AGENDA
ST. TAMMANY PARISH ZONING COMMISSION MEETING
6:00 P.M. – TUESDAY, MARCH 7, 2023
ST. TAMMANY PARISH ADMINISTRATIVE COMPLEX, COUNCIL CHAMBERS
KOOP DRIVE OFF OF HIGHWAY 59
MANDEVILLE, LOUISIANA

Proposed Use: Monarch Wellness Urgent Care: Change of Use **Gross Area Lot Size:** 1.267 acres
Previous/Current Use: Office **Use Size:** 2,400 sq. ft.
Owner: Chris Combs Properties, LLC **Council District:** 1
Applicant: Chris Combs **Posted:** February 17, 2023
Commission Hearing: March 7, 2023 **Prior Determination:** Denied - December 6, 2022

SHEET
C-1

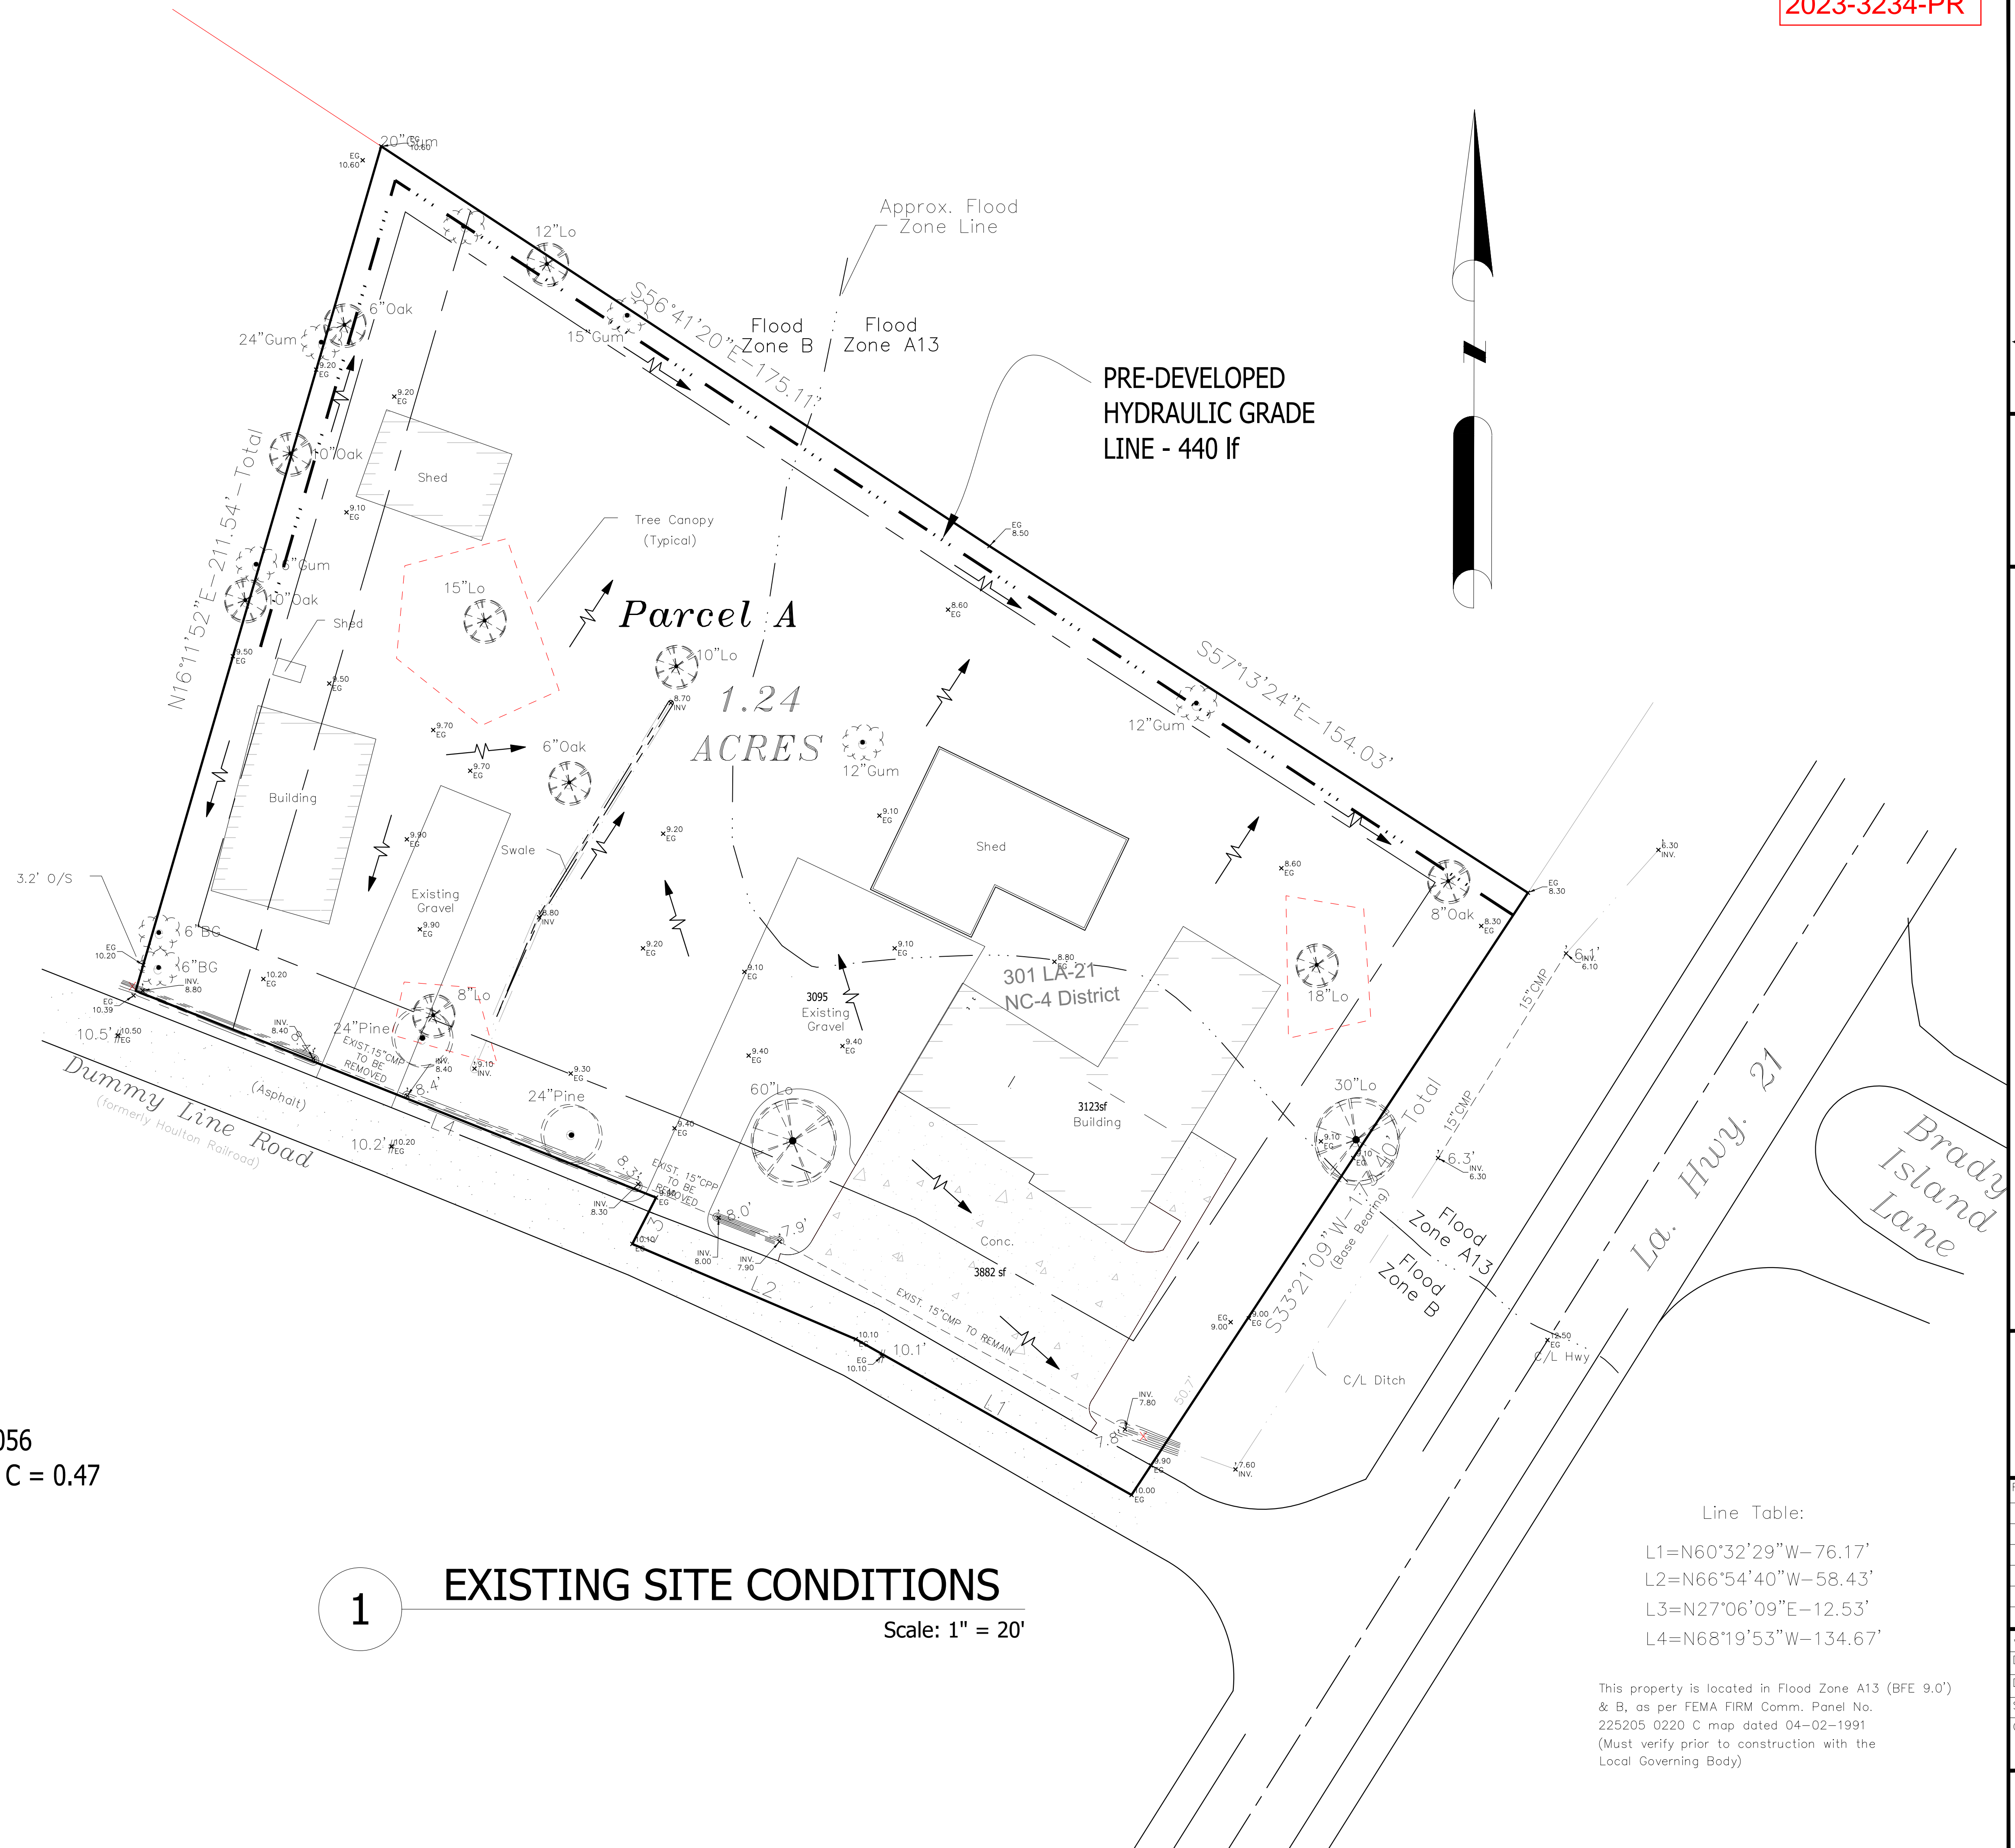
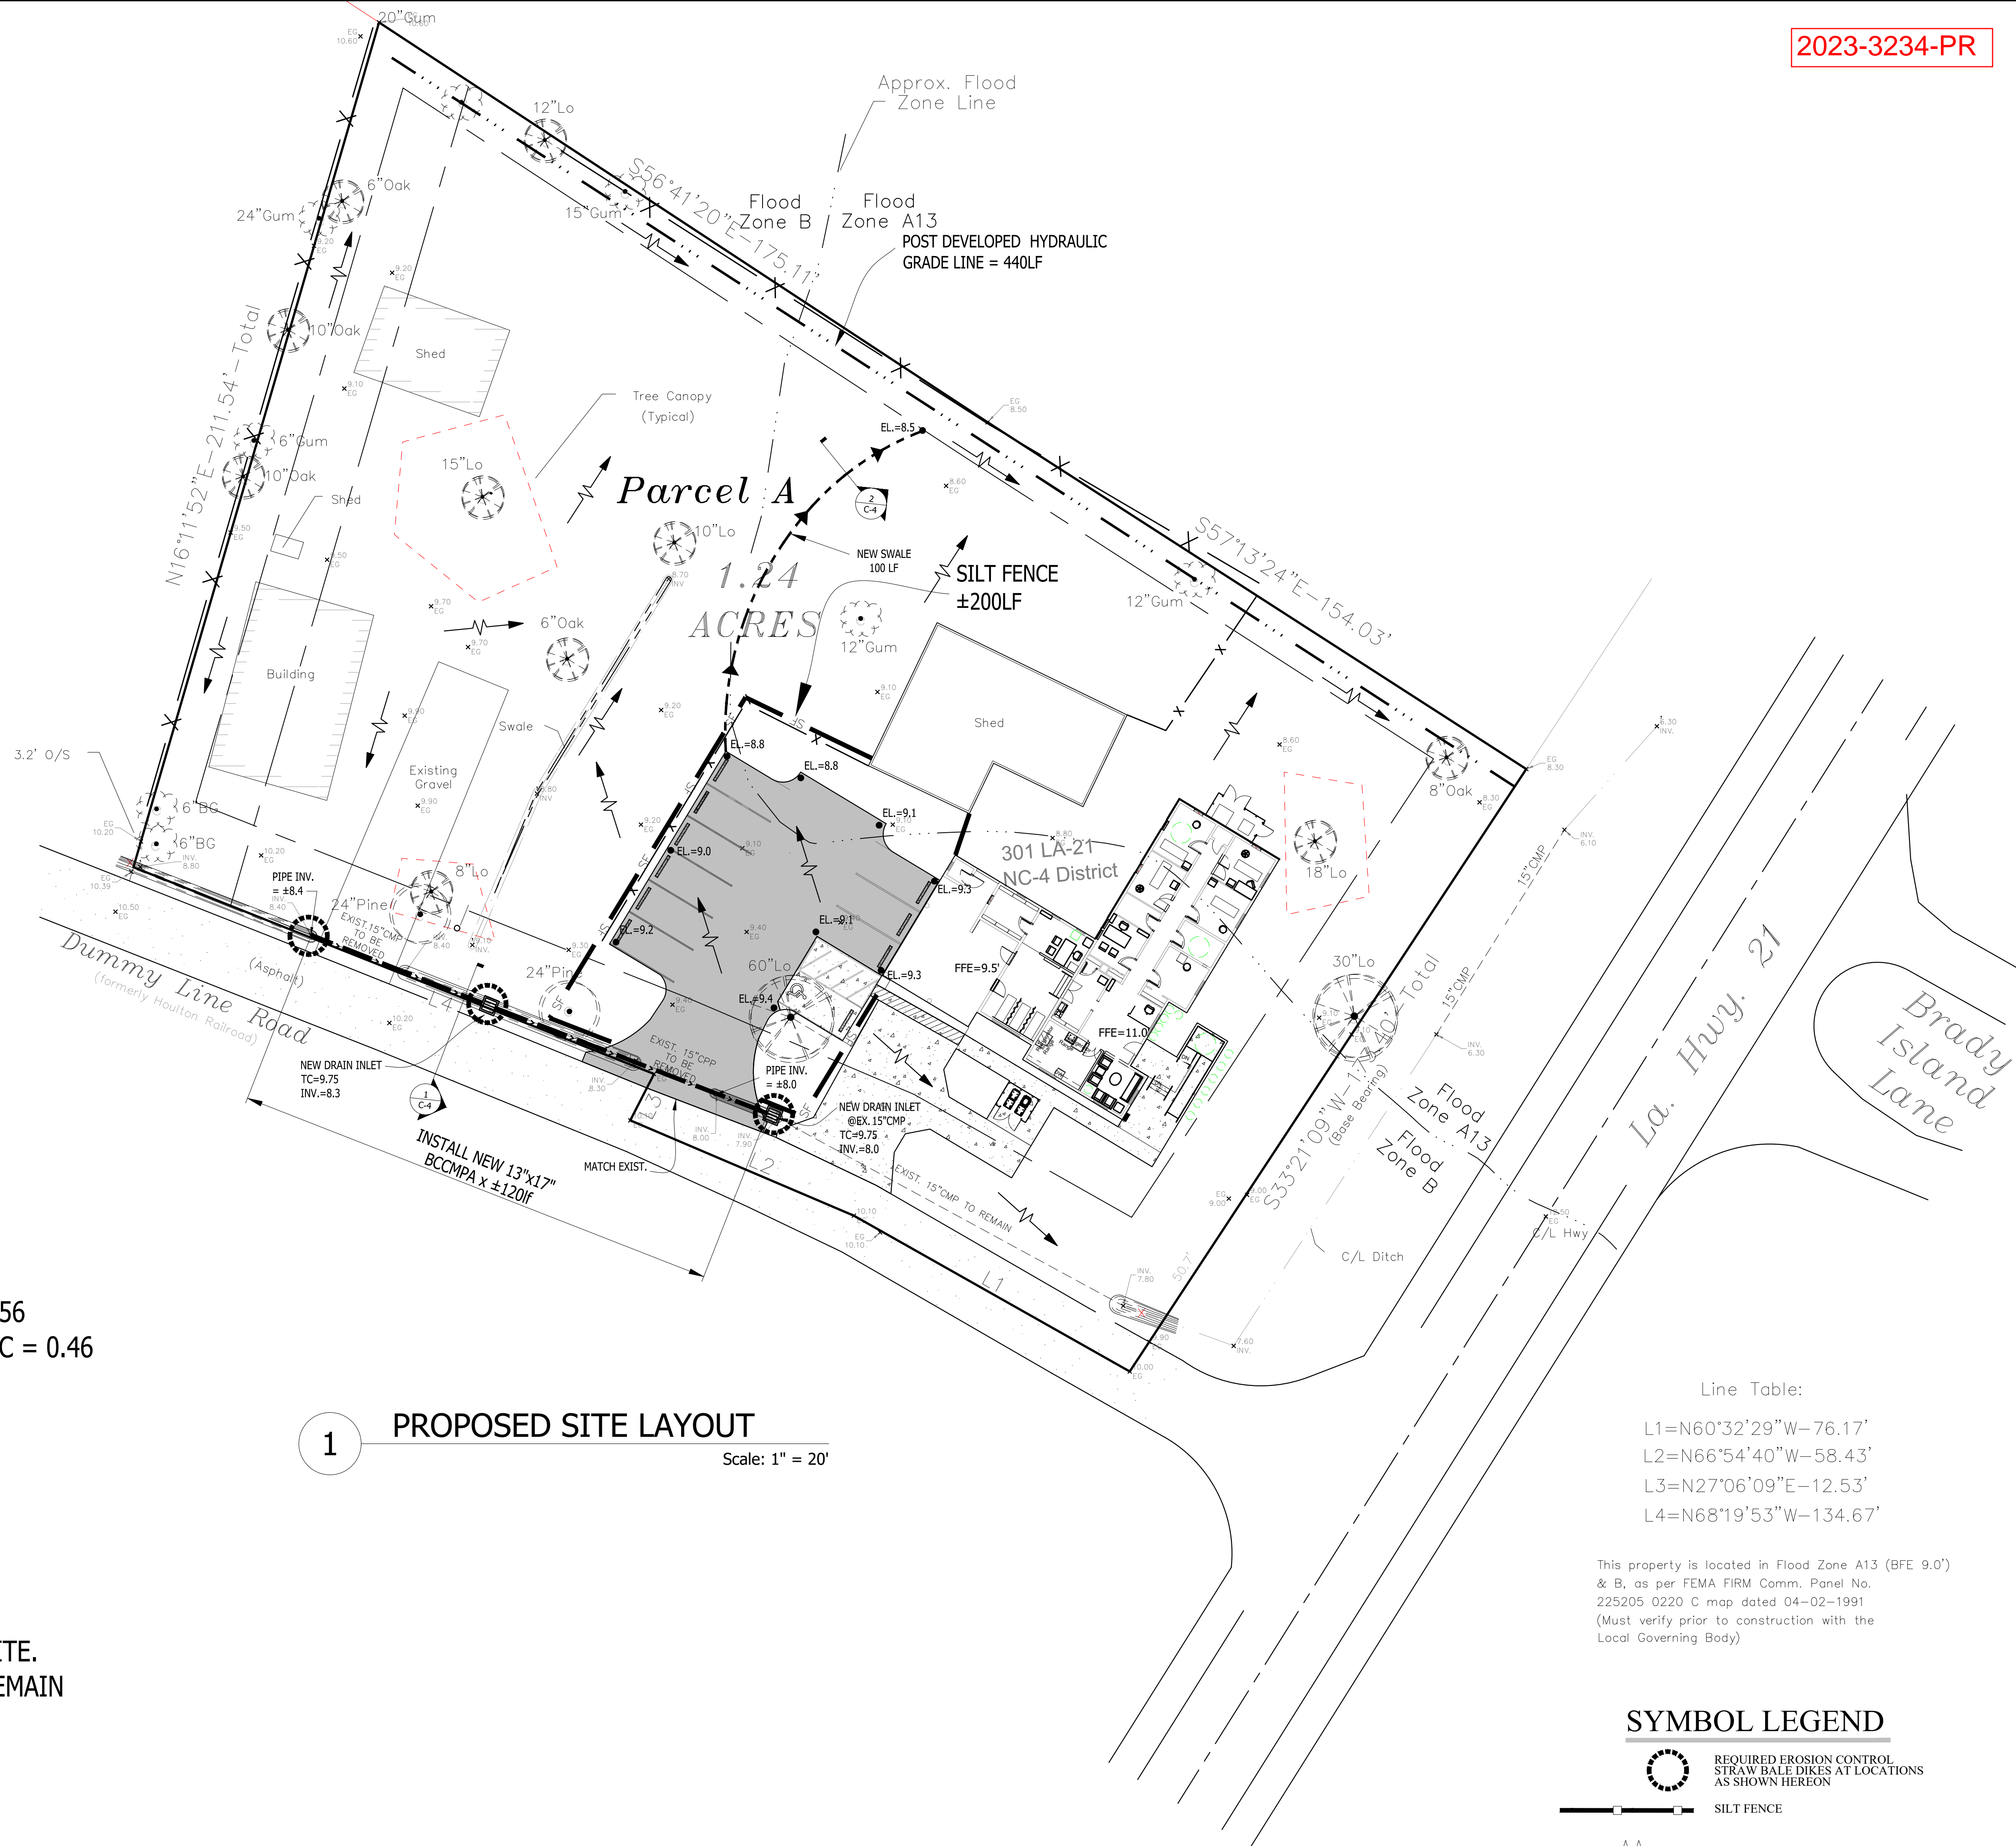
- **The proposed landscape plans show an existing 8" oak, an existing 18" live oak, and an existing 30" live oak within the Highway 21 street buffer. This provides the applicant a total of 10 tree credits, therefore reducing the total plantings required to 13 Class A trees and 35 Class B trees.**

- **The landscape plan provided is proposing to plant 2 additional Class A trees and 4 additional Class B trees. Therefore, the applicant is requesting a waiver to the required number of trees within the Highway 21 Street Planting buffer for the following: 11 Class A trees and 31 Class B trees.**

- **Staff recognizes a portion of the existing building and an existing concrete pathway from the parking lot to the front door of the establishment impedes upon the required 40' street buffer, therefore eliminating plantable area. Staff also recognizes the existing large oak trees within the street buffer also impede the plantable area. The landscape plan submitted shows an abundance of trees proposed within the buildable area of the site that are not required, therefore mitigating the reduction of required Class A and Class B trees in the Highway 21 street buffer.**

- **Existing conditions on the site provide 5 parking spaces which are located along the southern side of the building façade and currently back into the Dummyline right-of-way. While the previous site and landscape plan for the property (Case No. 2022-3128-PR) was proposing to maintain this existing parking configuration, the applicant has submitted new documents for review which are proposing the removal of the five existing parking spaces along Dummyline in order to provide the required 20 ft. street planting buffer and a more appropriate on-site circulation pattern.**

- **The current configuration of the property shows an existing 20' gravel driveway servicing the residential dwelling to the west of the site, an existing 24' concrete driveway servicing two parking spaces under an existing carport towards the eastern end of the site, and a proposed 24' concrete driveway to service the new proposed parking lot. This proposal exceeds the number of driveways which are permitted through a street planting buffer and will therefore incur a waiver request to the number of two-way-driveways allowable on a site. Staff recommends the applicant**

revise the plans to show the current driveway to the east of the site and the proposed parking lot driveway be connected and therefore reduced to 1-way driveway widths.

5. Per Sec. 130-1976, a street planting area is required to provide 1 Class A tree, 1 Class B tree, and 1 shrub per 30 linear feet of street buffer.
 - **The Dummyline Road right of way requires 9 Class A trees, 9 Class B trees, and 27 shrubs. The proposed landscape plan shows an existing 8" Live Oak, an existing 24" Pine, and two existing 6" Black Gums for a total of 9 tree credits. The landscape plan proposes to plant 6 additional Class A Live Oak trees and 3 additional Class B Iron Wood trees, therefore meeting the requirements of the street planting area.**

6. Per Sec. 130-1814(1)(e)(1)(ii), a non-residential property abutting a residential district shall have a minimum side yard and rear yard requirement of 30 feet.
 - **The western boundary of the property abuts a residential district, therefore requiring a 30 ft. rear yard buffer. This portion of the property is currently developed with an existing house and shed which encroaches upon the 30 ft. buffer. Although this area is outside of the scope of work as indicated by the "limit of work" line, the applicant is proposing to exceed the required number of trees by planting 6 new Ironwoods, therefore increasing the buffer between the adjacent residential zoning district and the existing commercial site.**

7. Per Sec. 130-1977, the landscape plan must provide a 10 ft. side yard buffer with 11 Class A trees and 11 Class B trees.
 - **The landscape plan submitted shows a 10 ft. side yard buffer with 11 tree credits and 11 additional Class B trees, therefore meeting the ordinance.**
